Winterlakes Tract F Replat Dollar General Landscape Modification Application

Project No. P22-148

Proposed Landscape Plan

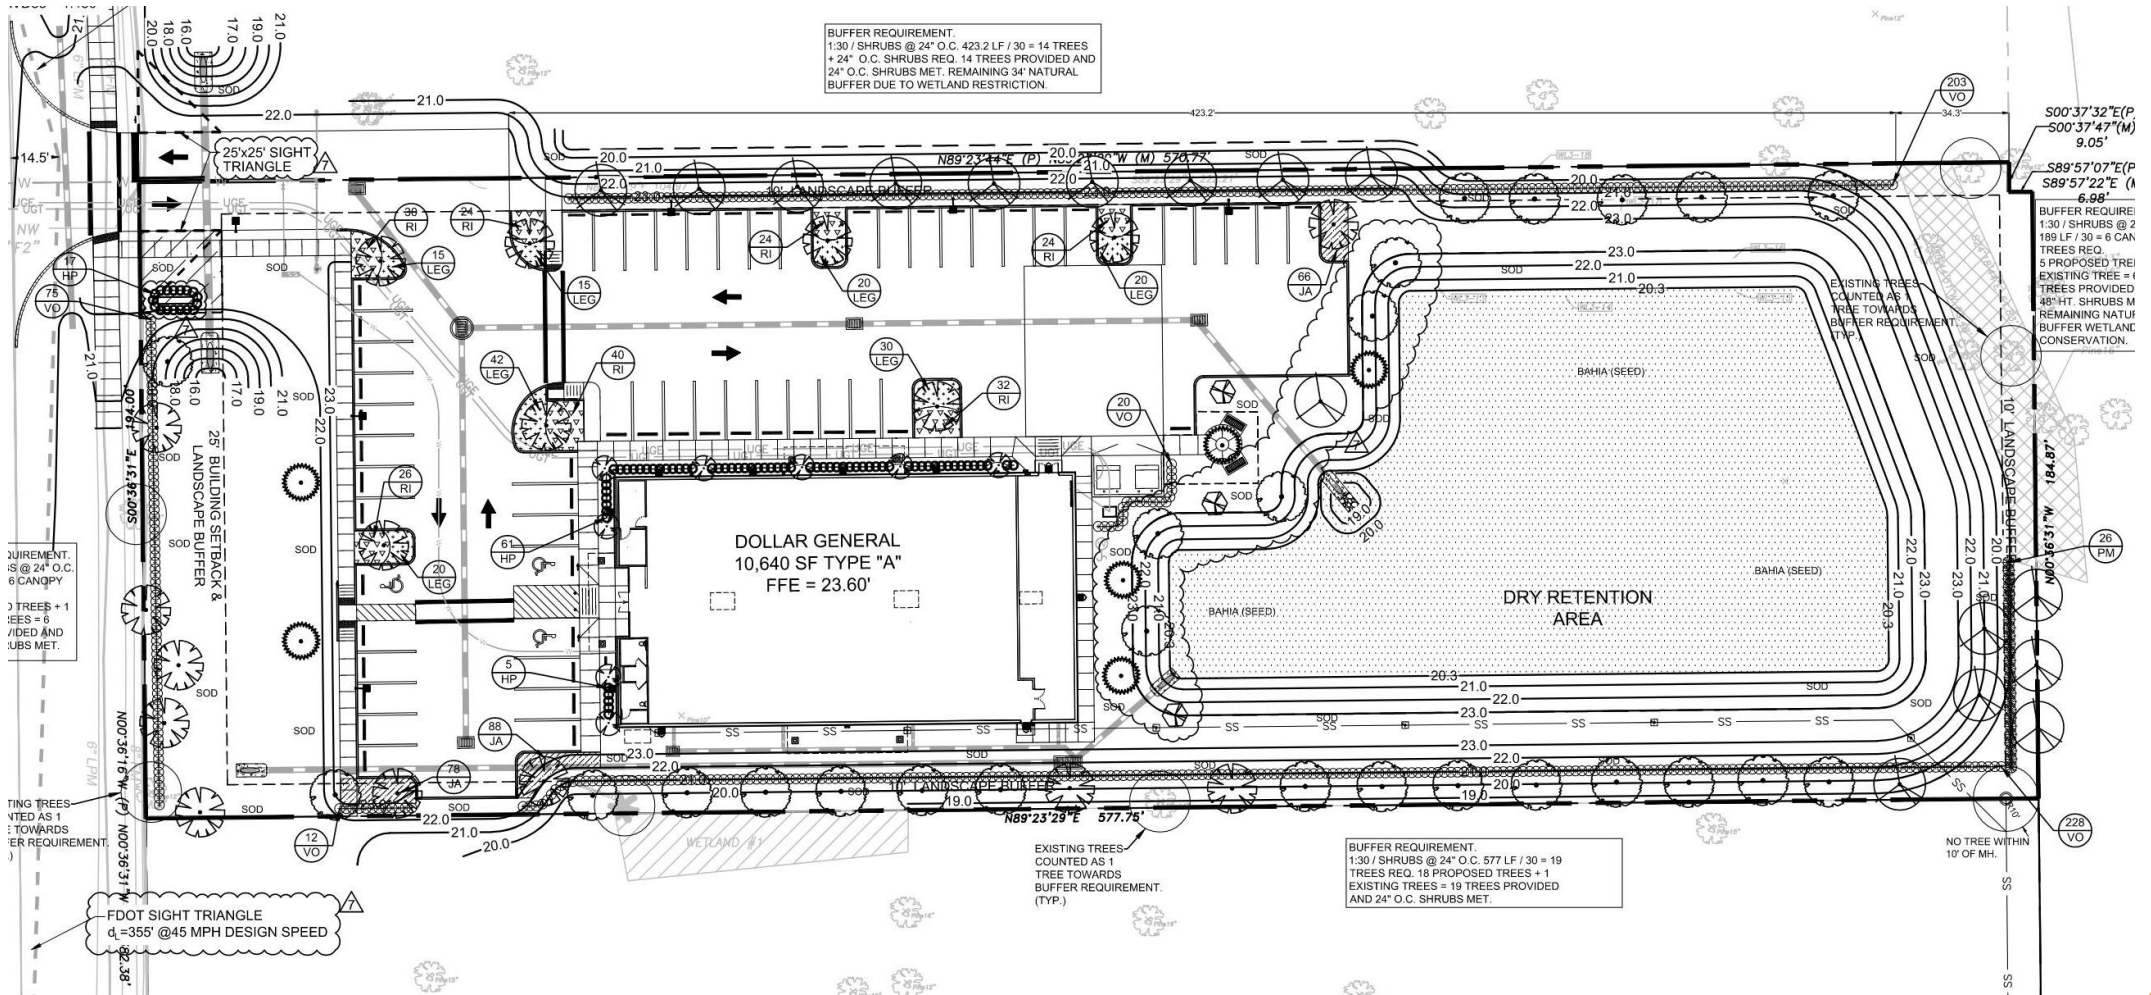
The applicant is proposing to install a hedge row of Podocarpus along the southern portion of the eastern boundary (outside the wetland), with 5 live oaks on either side.

Additional trees are provided on the opposite (western) bank of the retention pond. The proposed trees are 5 Bald Cypress, 3 Gumbo Limbo and 1 Live Oak.

The proposed Podocarpus hedge, planted at four foot in height to be maintained as a six-foot hedge along the portion of the eastern perimeter of the property outside the wetland.

The north portion of the eastern boundary will continue to be natural, with the existing trees remaining in the wetland.

Staff notes there is at minimum 184-foot separation between the use and the residential property line, which includes a 24,752 square feet of dry retention pond, jurisdictional wetland, and Seasonal High-Water Elevation (SHWE) areas.

Staff notes that the residential property is a 50' wide buffer tract, adding to the distance from the nearest residential property line to the use being buffered.
